Hotops Cycle Path Alignment Options Assessment

Prepared for Queenstown Lakes District Council

Reference: TOC 1 – Street Upgrades Package

Revision E

Figure 2: Layout of Options

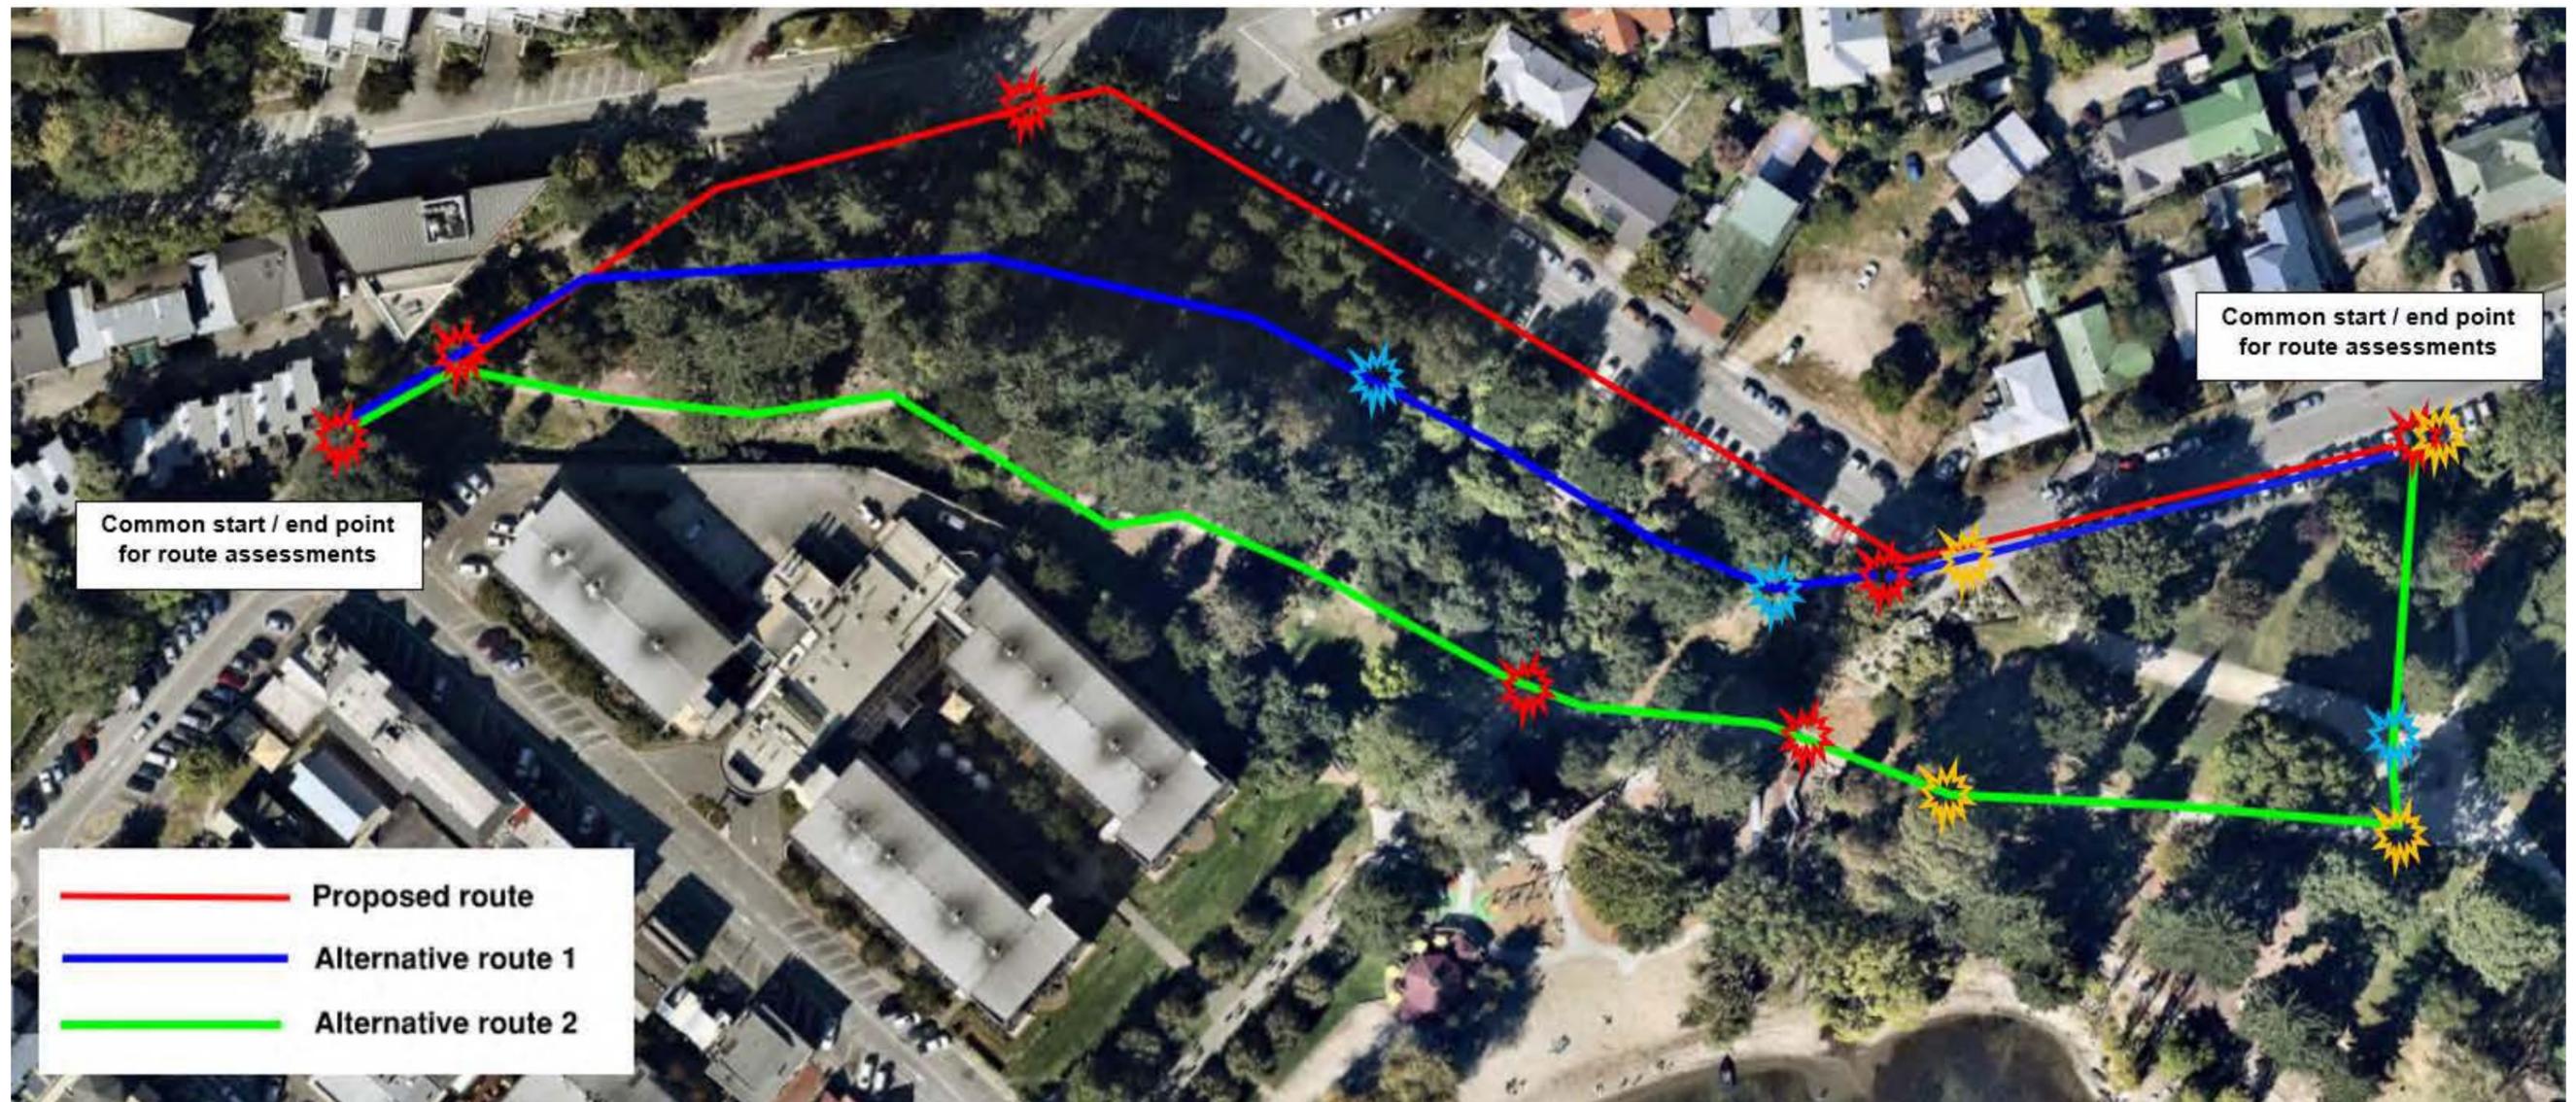
Figure 1 below illustrates the routes assessed, while also identifying the areas where a path conflict exists.

From the options assessed, the location of the southern end is not common for all options (see Figure 1 above). There is a risk that the shorter routes may not consider the risk / issues associated with the unassessed sections. For example, for cyclists to access the Preferred Route (PR) they need to travel along Park Street on the new shared path - this may present additional conflict points and it is unclear if they have been included in the Assessment.

GHD Comments – 15 November (with updates from 22 November)	Kā Huanui a Tāhuna Response	Kā Huanui a Tāhuna Actions
2.1.1	<p>Assessment Length</p> <p>From the three options assessed, the location of the southern end is not common for all options (see Figure 1 above). There is a risk that the shorter routes may not consider the risk / issues associated with the unassessed sections. For example, for cyclists to access the Preferred Route (PR) they need to travel along Park Street on the new shared path - this may present additional conflict points which is unclear if they have been included in the assessment.</p> <p>Recommendation – Review route extents to include for a common southern start / end point.</p>	<p>Agreed with defining route extent for purposes of assessing conflicts.</p> <p>Conflict points for the Preferred route have been considered on Park Street, up until the Gardens are entered.</p>	<p>Plan layout has been updated to include conflict points on new Park Street shared path and common start / end points.</p>

Figure 2-1: Previous design at Camp Street roundabout

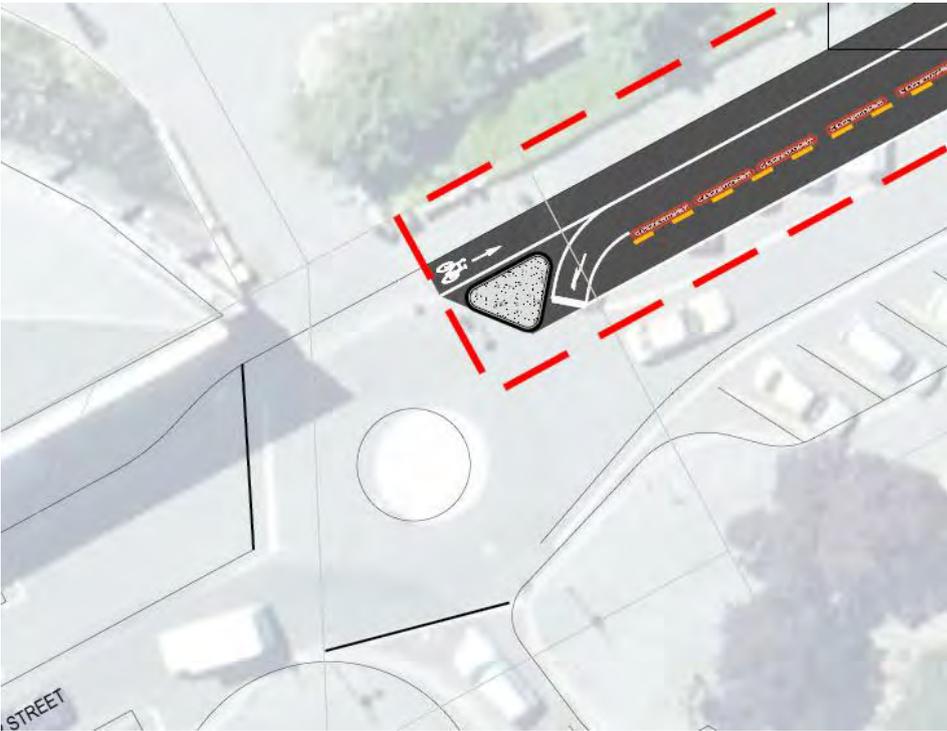
The 2019 design had a two way cycle lane on the north side of Camp Street separated from the traffic lane by physical dividers as shown below. The most significant change is that eastbound cyclists will share the carriageway with general traffic while westbound cyclists will have a separated cycle path on the south side of the road. To do this parking on the south side is removed while parking on the north side is retained, the reverse of what was proposed earlier.

The supplied plans do not show the above intersection therefore it is not clear how cyclists will enter the existing roundabout. Church Street users do not currently have to give way to much traffic, just that from the Police station and those cars doing u-turns. Cyclists coming out of the one way section of Camp Street will have the right of way at a roundabout however there is the potential for drivers not to appreciate this due to them travelling against the normal flow of traffic and thus failing to give way.

Crashes are likely to be infrequent	Death or serious injury is likely	The safety concern is moderate
Designer response	The updated design as agreed with QLDC has westbound cyclist on Camp Street approaching the Church Street intersection on the southern side. It is believed that drivers approaching Camp Street from Church Street will see and give way to cyclists on their right as per the standard give way rules.	
Safety Engineer comment	Agree with Designer's response.	
Client decision	Agree with Safety Engineer's comment.	
Action taken	No action to be taken.

Figure 2-2: Cycle symbol in front of service box

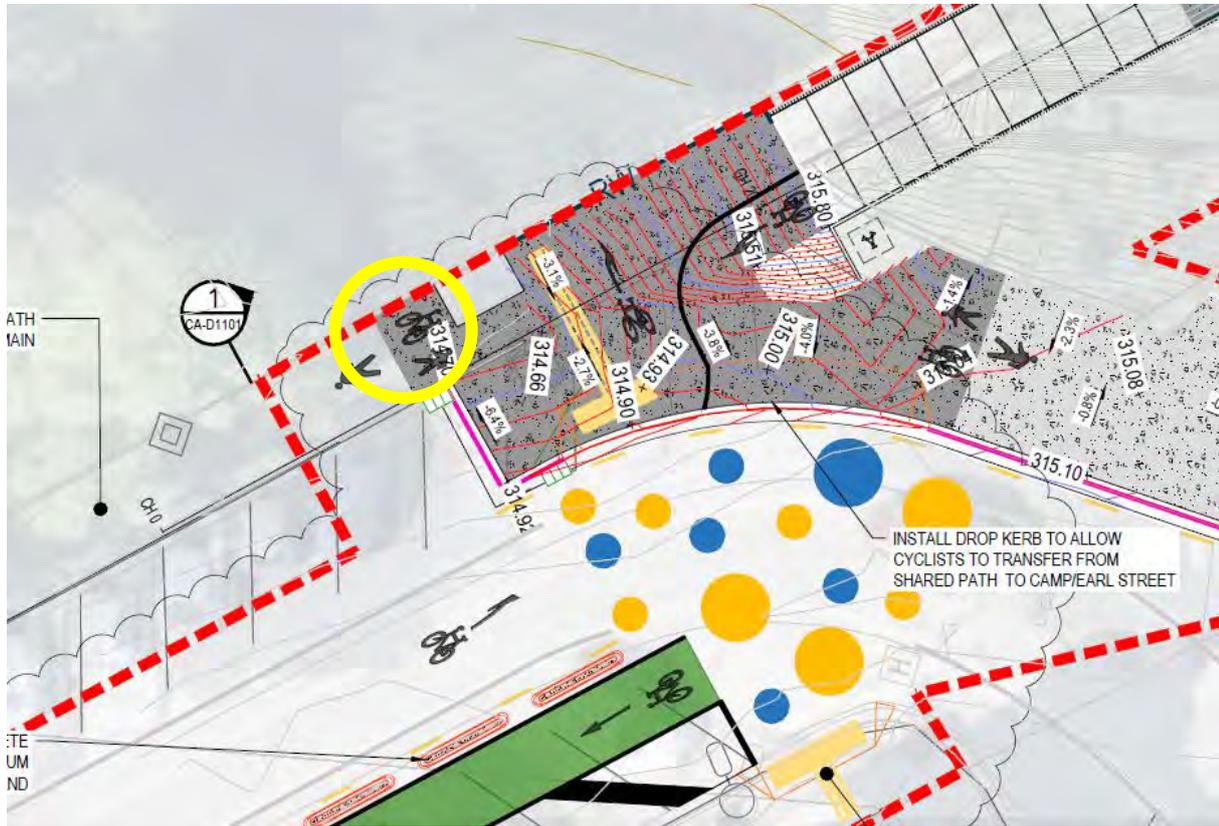
The SAT found that the various pedestrian and cyclist symbols on Sheet 2 of 8 were confusing and need to be complemented by wayfinding signs to direct both pedestrians and cyclists to the areas dedicated for them, whether crossing points or the actual track where it diverges on Hotops Rise. The location of the symbol markings also need to be reviewed, with one cycle symbol being shown placed in front of a service box as shown below.

The Road Markings and Signs Plans do not actually show any signs at this end of the cycle path. The SAT believe that signs will be critical to the correct use of the paths that are to be provided.

- 3. Review the location of the pedestrian and cycle symbols along the route.
- 4. Ensure that all signs are shown on the construction plans.

Crashes are likely to be infrequent	Death or serious injury is unlikely	The safety concern is minor
Designer response	We note the Safety Audit comments. The large square shown on the design drawing are actually the Telecommunication pit covers and does not provide a restriction to the existing footpath and proposed shared path. The pavement markings within the share space have been agreed with QLDC especially the markings for cyclists to guide them between the Horne Creek Bridge and Camp Street and Earl Street intersection.	
Safety Engineer comment	<p>Additional signage at the ped & cyclist shared space/ped only spaces needed. An additional vertical element to indicate change, and clearly show pedestrians they are entering an area with cyclists, and for cyclists to clearly see they can no longer travel on the footpath.</p> <p>Additional right turn arrow to be included with the left turn arrow above the Camp Street cycle sharrow to show that cyclist could also turning into Earl Street.</p>

Agree with Designer's other comments about the cover.
Client decision	Agree with Safety Engineer's comment.
Action taken	Design to be updated to include: <ul style="list-style-type: none"> • Addition signage at the transition between shared space and footpath to inform both pedestrians and cyclist the start and end of the shared space. • Right turn arrow on Camp Street cycle sharrow.

Figure 2-4: Potential conflict point on Park Street

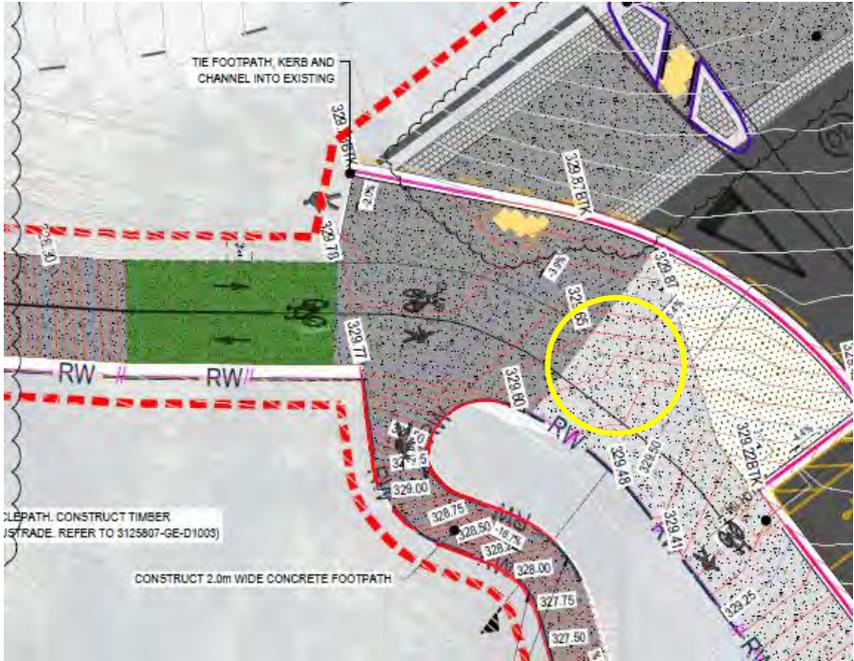
Our 2019 report raised an issue where the existing footpath that links Coronation Drive to the Gardens is realigned at the Coronation Drive/Park Street corner to allow for the intersection of the new cycleway. The new footpath meets the Hotops cycleway at right angles and on an incline. Cyclists and pedestrians may not be aware of each other at this potential conflict point.

A number of safety issues are raised relating to this conflict point. Pedestrians may continue walking along the path without realising that they are crossing the path of cyclists. It is assumed that pedestrians are not likely to be looking out for hazards because they are on an off-road footpath. Prams/strollers being pushed by pedestrians may protrude into the cycleway before the user realises that they have reached a cycleway. The route for pedestrians is not clear when they reach this conflict point traveling from the Gardens. Pedestrians may turn left into the cycleway instead of using the footpath on Coronation Drive. This again supports the need for a clear wayfinding signage plan.

Figure 2-4 also shows an inconsistent treatment for the tactile paving. At Camp Street/Earl Street directional paving is used to intercept any footpath users. At the top of Park Street directional pavers are not used. Whilst this is a large area consideration does need to be given to guide visually impaired footpath users to the new crossing point that is being provided.

Crashes are likely to be infrequent	Death or serious injury is likely	The safety concern is moderate
Designer response	Support the recommendation by the Road Safety Audit. Directional tactile paving to be included. IFC drawings to be updated to reflect this change.	
Safety Engineer comment	Agree with Designer's comments. Additional issue not addressed with recommendation regarding pedestrians turning onto cycle path. Add additional sign between the separate cycle path and pedestrian path with stacked on left [cycle symbol "ONLY" left arrow]; vertical separation line; [stacked on right [pedestrian symbol "ONLY" right arrow] – similar to sign RLU4.	
Client decision	Agree with Safety Engineer's comments.	
Action taken	Design to be updated to include: <ul style="list-style-type: none"> • Directional tactile paving to be included on Park Street. • Add additional sign between the separate cycle path and pedestrian path with stacked on left [cycle symbol "ONLY" left arrow]; vertical separation line; [stacked on right [pedestrian symbol "ONLY" right arrow] – similar to sign RLU4.
